UNITED STATES PATENT AND TRADEMARK OFFICE

APPLICATION NO.	FILING DATE	FIRST NAMED INVENTOR	ATTORNEY DOCKET NO.	CONFIRMATION NO.
09/750,474	12/28/2000	William J. Harrison	ACS-55966 (26991)	6584

Office Action Summary	Application No.		Applicant(s)	
	09/750,474		HARRISON, WILLIAM J.	
	Examiner		Art Unit	
	Vy Q. Bui		3731

DETAILED ACTION

ALLEN's Fig. 8

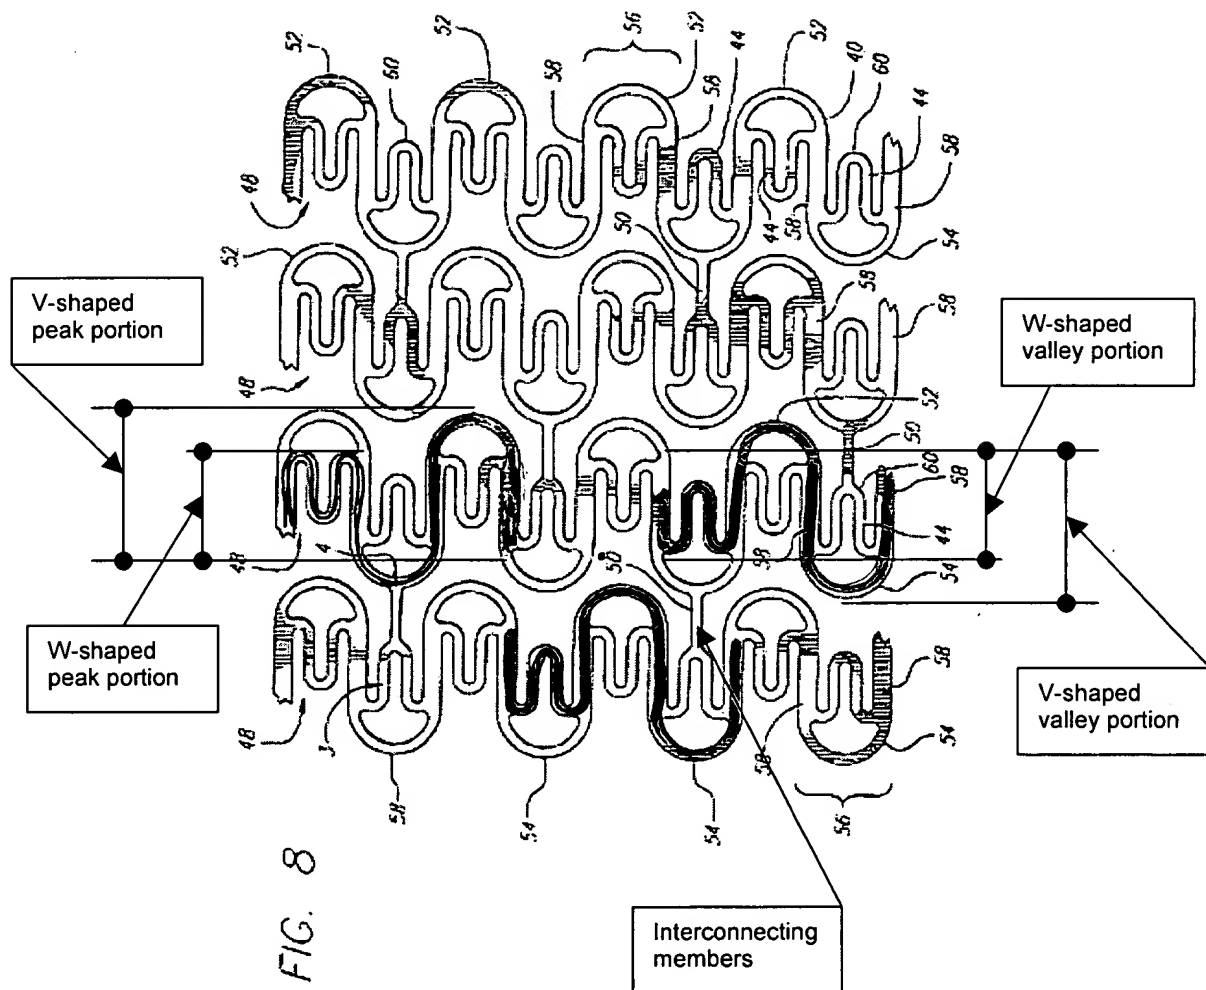
As to claims 1, 3-4, 6-7, and 21-22, ALLEN (see Fig. 8 reproduced and shown in page 2) discloses a balloon assisted expanding stent (see page 2, lines 1-6, section [0016]) or a self-expanding stent (see page 2, lines 7-10, section [0018]) comprising V-shaped and W-shaped peak portions (in red color), V-shaped and W-shaped valley

portions (in green color), wherein W-shaped portions are smaller in length than the V-shaped portions as recited in the claims.

As to claims 8-10, ALLEN (see Fig. 8 reproduced and shown in page 2) discloses a stent comprising V-shaped and W-shaped peak portions (in red color), V-shaped and W-shaped valley portions (in green color), wherein W-shaped portions are smaller in length than the V-shaped portions as recited in the claims. Further as to claims 13-16 and 11, Fig. 8, page 3, shows valley portions (in green color) and a connecting member (in yellow color) as recited in the claims.

As to claims 17-19, ALLEN (Fig. 8 reproduced and shown in page 2) discloses each cylindrical element has at least 4 W-shaped valley portions adjacent to at least 4 V-shaped valley portion and W-shaped valley portions are smaller than V-shaped valley portions.

As to claim 23, see ALLEN's Fig. 8, page 2.

As to claim 20, ALLEN (Fig. 8) does not show 8 peak portions and 8 valley portions. However, it would have been obvious to one of ordinary skill in the art to provide 8 peak portions and 8 valley portions to ALLEN stent as claimed to make a stent having larger diameter to fit a larger blood vessel.

Basically, the Applicant asserts that ALLEN reference and DANG reference identify peak portions, valley portions and interconnecting members differently from the way the Examiner does. In addition, the ALLEN V-shaped and the W-shaped portions may be not capable of nesting because of the existence of reinforcing members 44.

Notice that ALLEN and DANG stent structures are clearly shown in the drawings to clearly specify their inventions. Even ALLEN and DANG references identify and name various elements (cylindrical elements) and components (peak portions, valley portions) of the stents differently, the Examiner's rejection is considered proper and reasonable as long as the elements of ALLEN and DANG stents exist in drawings in the references as pointed out in the "Office Action". Further more, from ALLEN Fig. 8, because the members 44 are arranged longitudinally offset one to each other, under crimping, ALLEN V-shaped and the W-shaped portions are capable of being moved closer one to another to make nesting possible.

DANG'S FIG. 6

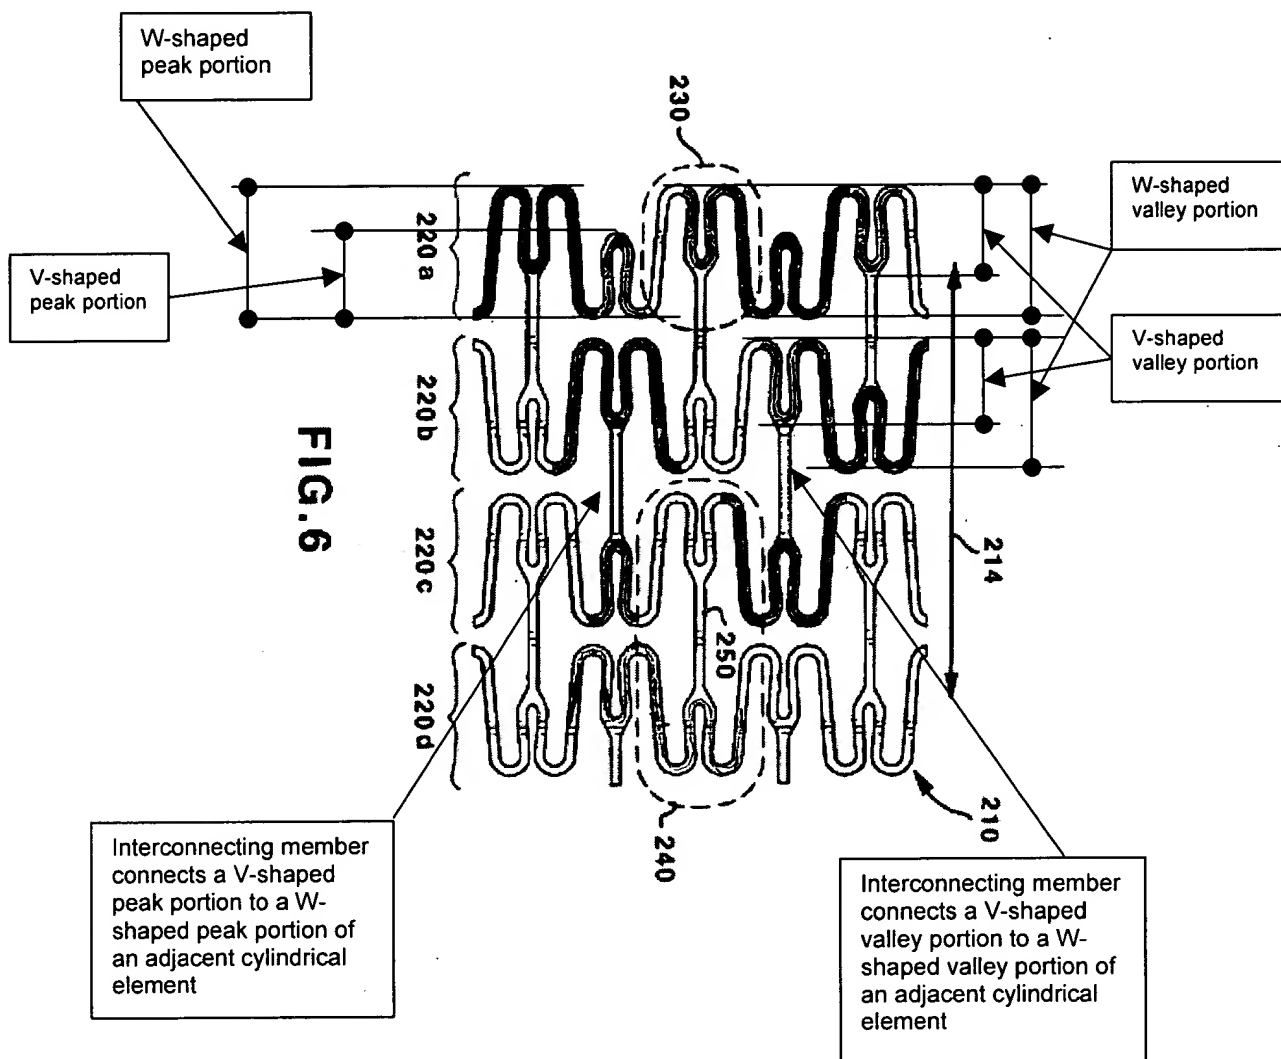
As to claims 1, 3, 6, 8-9, 11, 17-18, 21-23, 24-31, DANG (see Fig. 6 reproduced and shown in page 3) discloses a balloon assisted expanding stent or a self-expanding stent (col. 8, lines 31-35) comprising cylindrical elements of W-shaped valley and W-shaped peak/inverted W-shaped portions (in red color), V-shaped valley and V-shaped peak/inverted V-shaped portions (in green color), wherein W-shaped portions and V-shaped portions have different longitudinal lengths as recited in the claims. Two adjacent cylindrical elements are connected by inter-connecting members (in yellow) in a manner as recited in the claims.
